# **BROOKSIDE GOLF COURSE IMPROVEMENTS PROJECT**

## **INITIAL STUDY/MITIGATED NEGATIVE DECLARATION RESPONSE TO COMMENTS**

**MAY 2023**

##### Existing Proposal

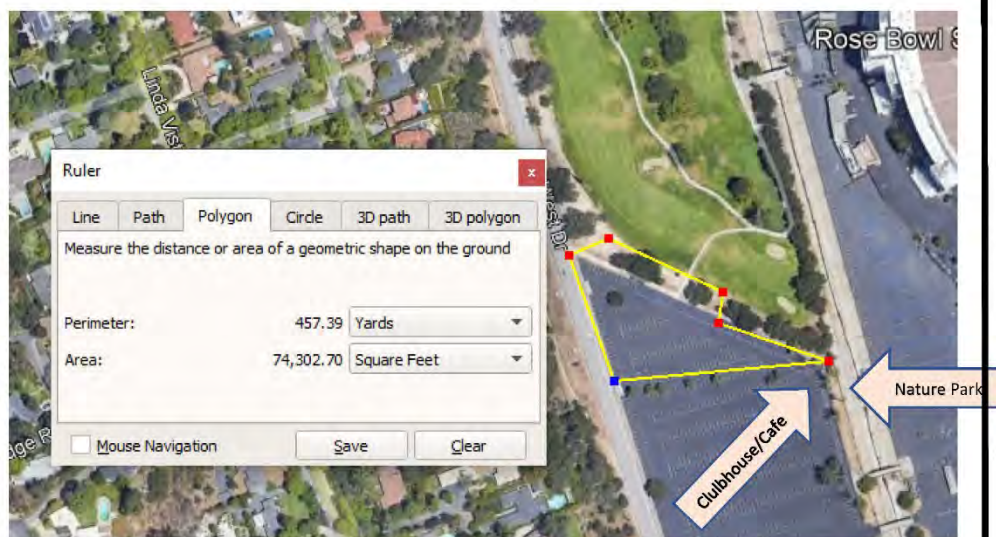
Challenging elements of the proposed miniature golf course at the western edge of the existing driving range are:

- The location is more than one-quarter mile from the prime parking area which is too far and would likely negatively impact long-term utilization
- The prime parking lot is heavily utilized and the additional volume of users would exacerbate the current situation
- The facility would have no exposure and an unattractive entryway along the driving range stalls
- The design does not include any additional amenities to make this an attractive recreational opportunity
- The overall benefit to the general public is minimal

##### Existing Proposal

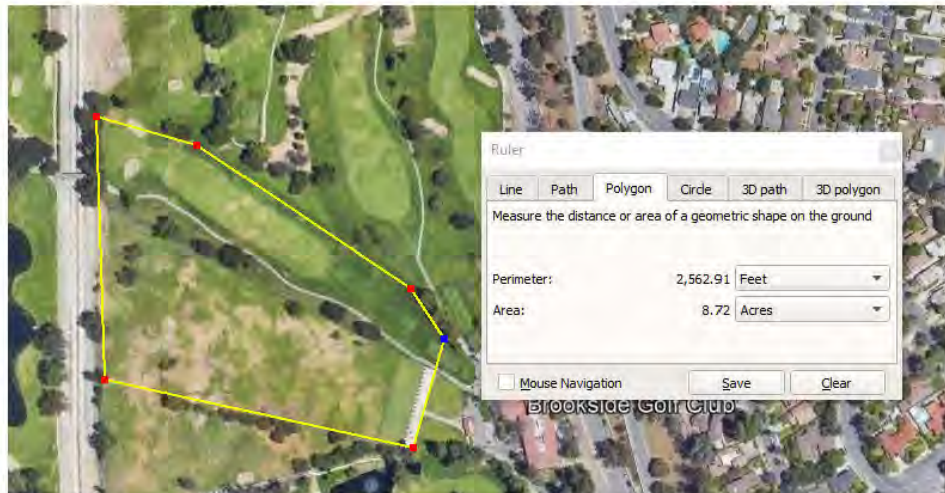
Challenging elements of the proposed driving range are:

- The negative impact on the E.O. Nay course is severe and the 6<sup>th</sup> hole as it exists is unique and should not be altered
- The proposed tree removal is extensive and unnecessary
- Lighting the driving facility is not compatible with the historic use or public benefit

R16-6

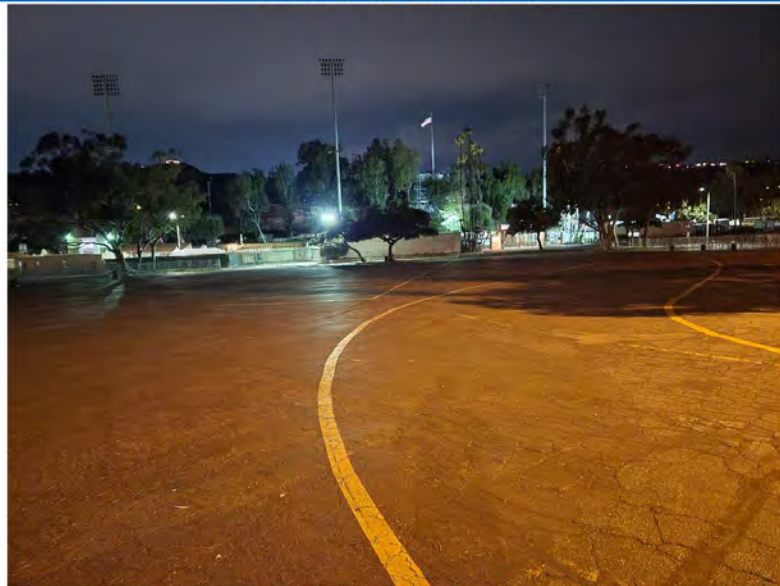
- The first three photographs demonstrate the extensive ambient light from fixtures at the Rose Bowl and associated parking lots.
- The 4<sup>th</sup> and 5<sup>th</sup> photographs show that the golf course is effectively dark beyond the lighting at the clubhouse and surrounding structures (the light in the driving range photograph is a maintenance worker on a tractor collecting balls).
